# Access Compliance Report Public Rights-of-Way (Curb Ramps)

Main Street: N\_GAYLE\_ST Cross Street: BIXBY\_AVE Location: NE

ADA ID: RPAT210924122156 Ramp Type: Type 1 - Perpendicular Diagonal Initial Pass/Fail: Fail Overall Compliance: No Severity Score: 16

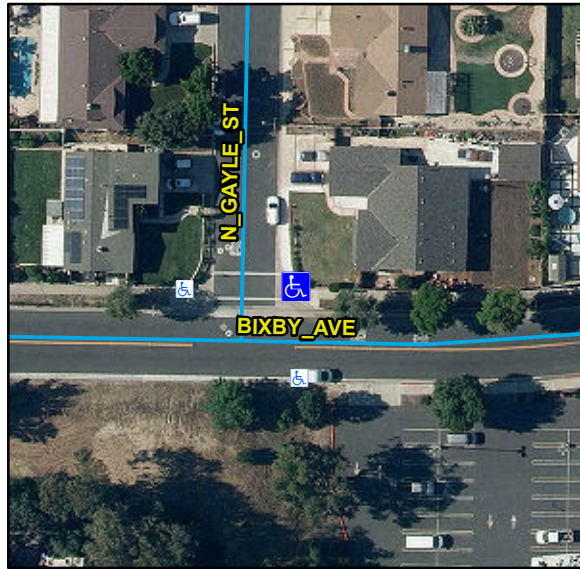
| Compliance | Description                           | Data | Compliance | Description                   | Data |
|------------|---------------------------------------|------|------------|-------------------------------|------|
| No         | Ramp Run Slope (%)                    | 8.8  | N/A        | Flare Slope LT (%)            | N/A  |
| No         | Ramp Cross Slope (%)                  | 5    | N/A        | Flare Traversable LT          | N/A  |

**Remove & Replace Curb Ramp With Two New Directional Ramps or Equivalent. Restripe Crosswalk.**

**R304.2.2, R204.3, R304.5.3, STD 1115**
